# PCI 9030

Errata Rev. 2.0

July 2005

## Errata Documentation

Block Diagram of one possible work around implementation

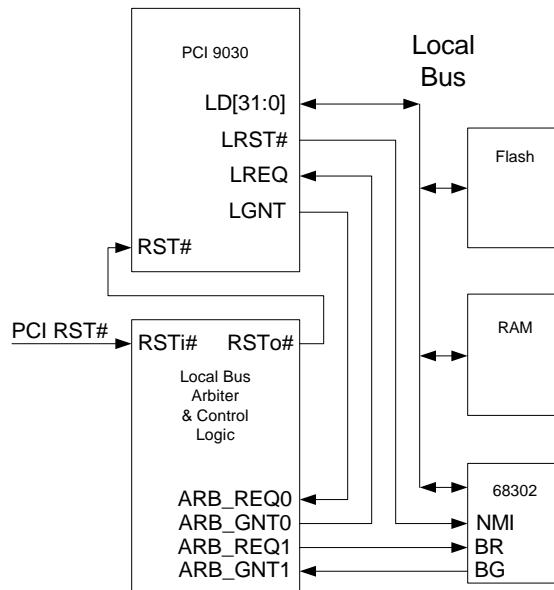
**Problem:** The PCI 9030 drives the LA[27:24] address pins (which can be configured as GPIO[4:7] pins after PCI reset completes), and Non-multiplexed mode LD[31:0] data or Multiplexed mode LAD[31:0] address/data I/O pins, low during PCI reset rather than to high impedance state. This may result in bus contention if other devices use these signals during PCI reset. The remaining address bus signals, LA[23:2], as well as the LBE[3:0]# byte enables, are floated during PCI reset.

4. Create external logic that controls the local bus arbitration and captures PCI RST# to provide a conditioned RST# signal to the PCI 9030. The basic concept is to always request the local bus from the PCI 9030 and only grant the bus to PCI 9030 when it informs the system that it needs the bus by negating its LGNT pin. Below is a detailed description of this workaround.

Below is a block diagram of one possible implementation, showing only the relevant signals. The necessity of this workaround is required only if the user does not want PCI reset to generate a system/board reset. Because the PCI 9030 drives the LA[27:24], LD/LAD[31:0], and LRST# pins low as long its RST# is asserted, bus contention will occur on the local bus if other local bus devices are using the bus at that time. The workaround concept is as follows:

- Capture the PCI RST#,
- “give” the local bus to the PCI 9030;
- assert a reset pulse on the PCI 9030 RST# pin for a minimum of 2 rising PCI clock edges;
- wait for the PCI 9030 to process its RST#;
- “take” local bus control back from the PCI 9030, resume normal local bus activity, prepare for the next PCI RST# after it negates

The workaround requires the PCI 9030 RST# signal to be asserted for a minimum of two PCI rising clock edges. If you only have access to the Local clock then you would need to determine the minimum frequency of PCI operation. A close approximation is - Minimum PCI frequency =  $2.01 \times 1/\text{period}$ , where period is the amount of time you assert RST#. If the PCI clock is available for use, the design can be constructed to ensure RST# is asserted for two rising edges, and using the PCI clock will allow the design to work down to 0.0 MHz. LREQ may be asserted before, during and/or after RST# and LRST# assertion.

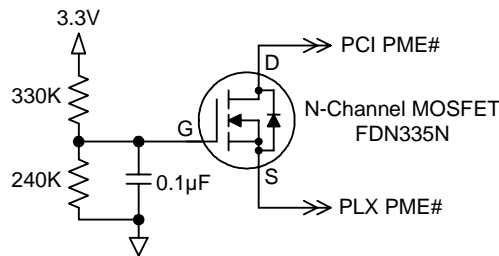
**Problem:** The PCI 9030 floats CS[3:2]#, LA[27:24], WAITo#, and LLOCKo# upon LREQ assertion.

1. Use CS[1:0]# instead of CS[3:2]# and/or do not implement designs that use LA[27:24], WAITo#, and LLOCKo#.
2. Use either of CS[1:0]# to gate LREQ input such that the PCI 9030 will see LREQ assertion only when it is not performing or about to perform a Local bus transfer. Using an AND gate, connect the CSx# output and the LREQ output from the Local bus master to the AND gate inputs, and connect the AND gate output to the PCI 9030 LREQ input.

Program the corresponding CS0BASE or CS1BASE register to assert the Chip Select (CS0# or CS1#) for all Direct Slave accesses to any of the implemented Local Address Spaces (0, 1, 2, 3 and Expansion ROM), by setting the Range encoding and the Base Address within the CSxBASE register to include all Local bus addresses accessible through Direct Slave transfers. The Chip Select will assert only for Local bus addresses that are mapped within any of the Local Address Spaces as defined by the LASxRR (Range) and LASxBA (Base Address, or Remap) registers.

Example: programming the CS0BASE or CS1BASE register with the value 08000001h will enable the Chip Select to assert for any Direct Slave access within the 256 MB address map.
